Project No. 23-01-200

Re: **Modification No. 8 to the Remedial Design Report**
Closure Unit Modifications
Three Kids Mine, Henderson, Nevada

Subject: Modification No. 8 to the Remedial Design Report
Closure Unit Modifications
Three Kids Mine Site, Henderson, Nevada

Figure 9
Closure Units
Three Kids Mine

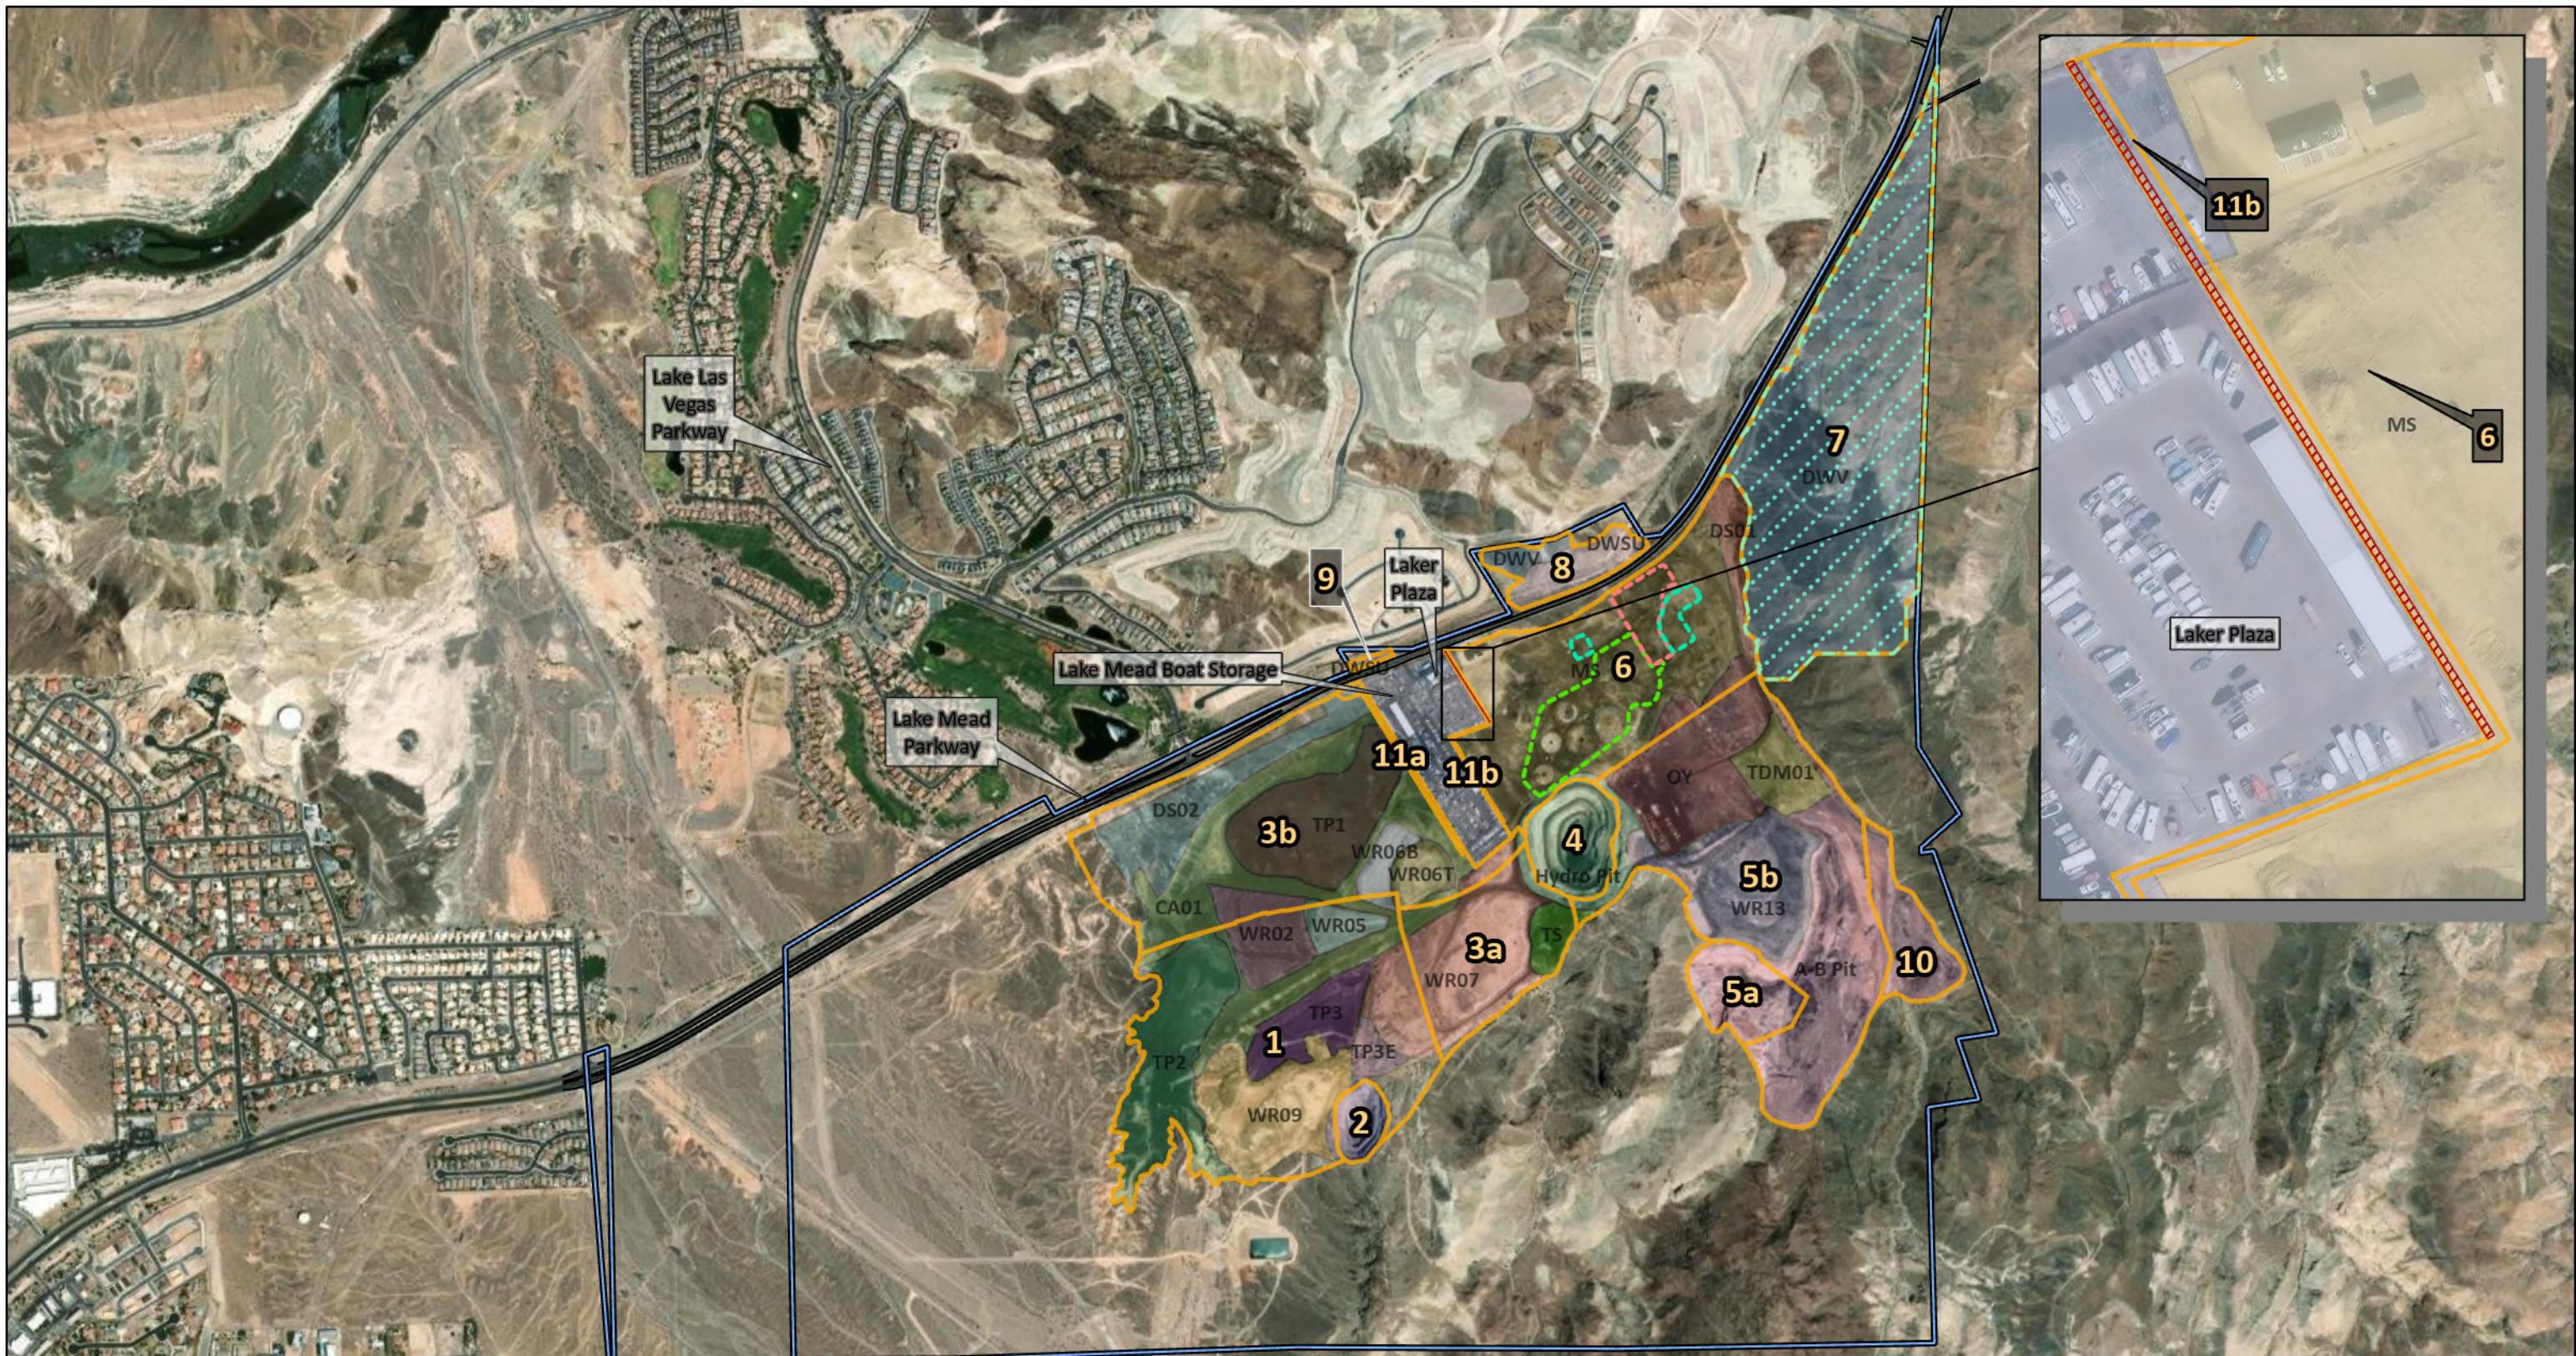
This Technical Memorandum presents Modification No. 8 to the *Remedial Design Report, Revision 1* dated March 4, 2024 (Remedial Design Report) for the Three Kids Mine Site (Site) in Henderson, Nevada. This modification details changes to Closure Units, which were developed to allow for a phased approach to closure at the Site and to account for differences in the selected alternative by geographic area. The rationales for changes to the Closure Units are described below and the new boundaries are reflected in Figure 9, attached.

Changes to Closure Units 1, 3a, 3b, 5b, and 6 were made to better align with development plans. The boundaries were adjusted to match the edges of lots and roads, where possible, and to allow for No Further Action (NFA) determinations to be obtained in a timeframe coordinated with development plans. Changes were minor, except in the northern movement of the boundary between Closure Units 5b and 6. There are no changes to the performance standards for these Closure Units as specified in Section 3.0 of the Remedial Design Report.

Closure Unit 4 corresponds to the former Hydro Pit. After placement of the tailings-waste rock mixture in the Hydro Pit was complete, the maximum lateral extent of the tailings mixture was surveyed at the surface. The redesigned liner included the lateral extent of the tailings mixture and added 2.5 feet to account for the anchor trenches designed to secure the liner. This boundary is reflected in the liner footprint presented in *Modification No. 7 to the Remedial Design Report* (Broadbent 2025). The final as-built liner edge was increased slightly outwards from the July 21, 2025 design in Modification No. 7 to smooth out edges on the north and west sides. The revised Closure Unit 4 takes the as-built liner footprint and adds an additional five-foot buffer around the edge of the liner. This approach means that Closure Unit 4 will encompass the entire lined Hydro Pit, without unnecessarily restricting nearby development. There are no changes to the performance standards for Closure Unit 4 as specified in Section 3.0 of the Remedial Design Report.

Closure Unit 11 consists of a buffer around two other properties within the former mine site: Lake Mead Boat Storage (LMBS) and Laker Plaza. Previously, Closure Unit 11 was a 10-foot buffer around the property lines on each side. Conditions on the ground will allow for placement of 10 feet of native soil cover to the south, southeast, and southwest of the LMBS property line, thus removing the need for Closure Unit 11

in those areas. Closure Unit 11 was broken into two subunits, Closure Unit 11a and Closure Unit 11b. Both areas will be restricted to non-residential development.

The impacted area boundary was modified slightly to exclude the Nevada Department of Transportation (NDOT) right-of-way, affecting Closure Units 3b (northwest corner) and 6 (northeast corner).

Closure Units presented herein were modified to align with development goals and to better reflect conditions on the ground. Revised Closure Units are depicted in the attached revised Figure 9. Closure Unit Work Completion Reports will depict the final boundaries of each Closure Unit.

A. 4.5 TO LMBS
NOT TO SCALE

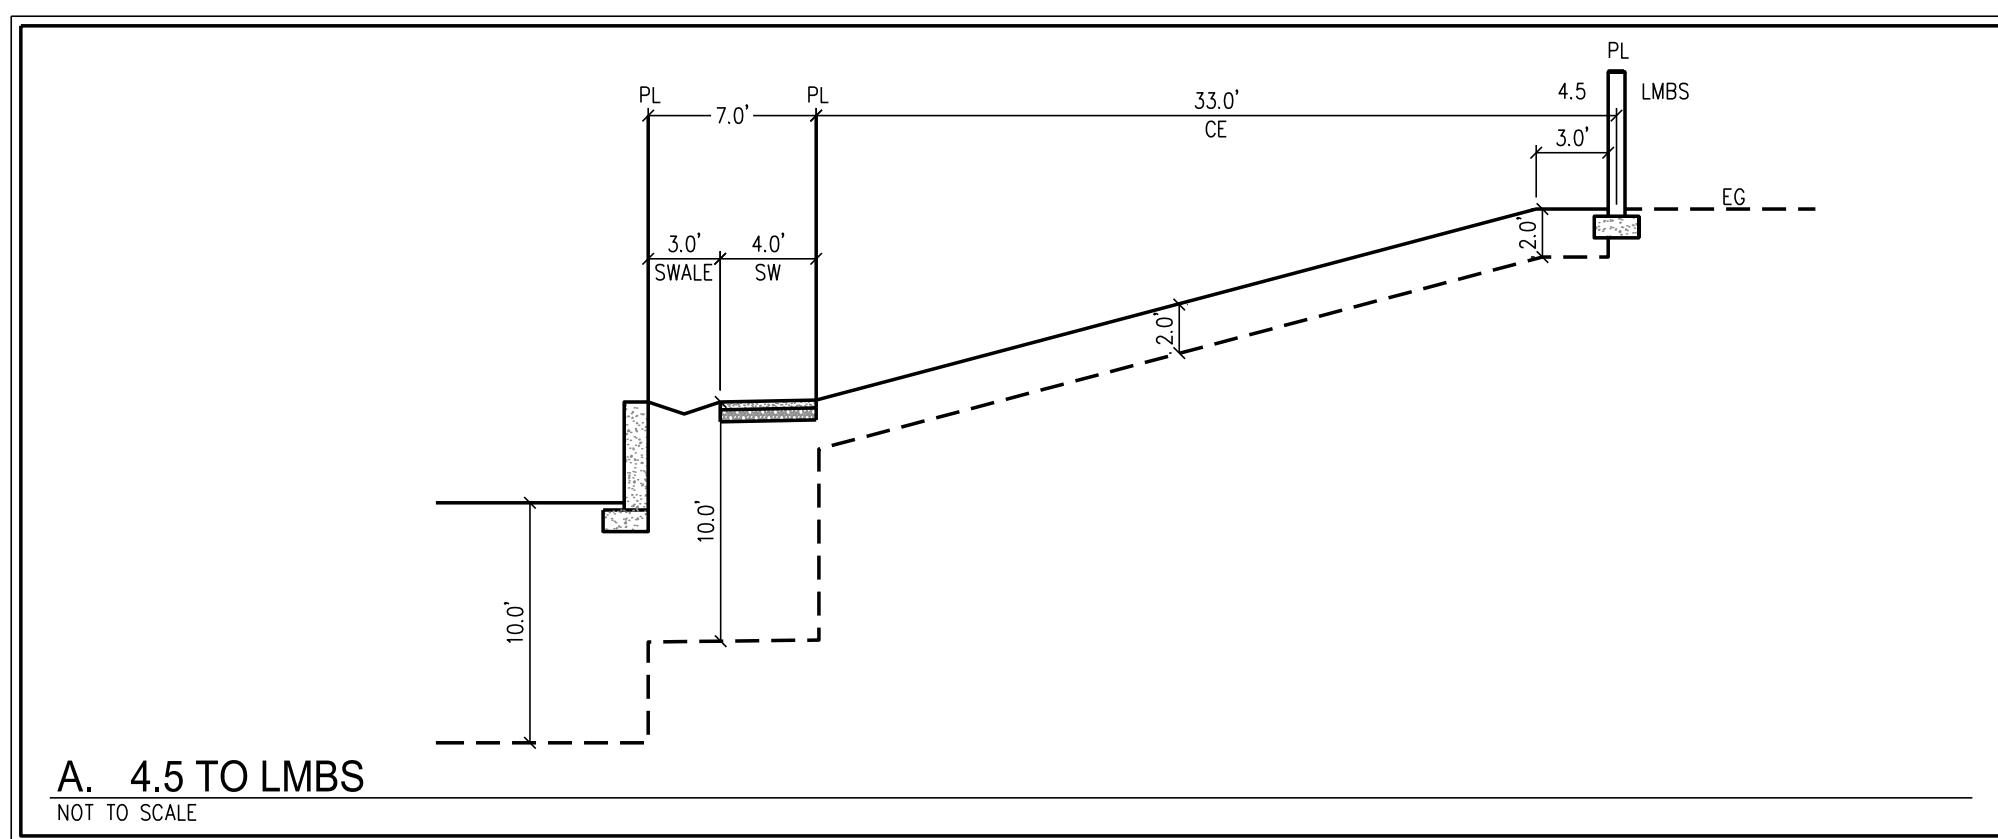
The west side of LMBS now consists of Closure Unit 11a, a 33-foot wide buffer from the property line. Closure Unit 11a, depicted in Cross Section A (Lakemoor Closure Unit Exhibit Detail), will consist of one Assessor's Parcel Number (APN) and receive a minimum of two feet of native soil cover. Closure Unit 11a will additionally consist of an area northwest of LMBS with existing fiber optic utility lines. To avoid disturbing the lines, final grades will be modified to allow for the placement of a minimum of two feet of native soil cover. Accordingly, the performance standard for Closure Unit 11 as stated in Section 3.0 of the Remedial Design Report is modified from "Placement of 10-foot cover or the maximum amount of fill possible... following safe work practices..." to placement of a two-foot cover.
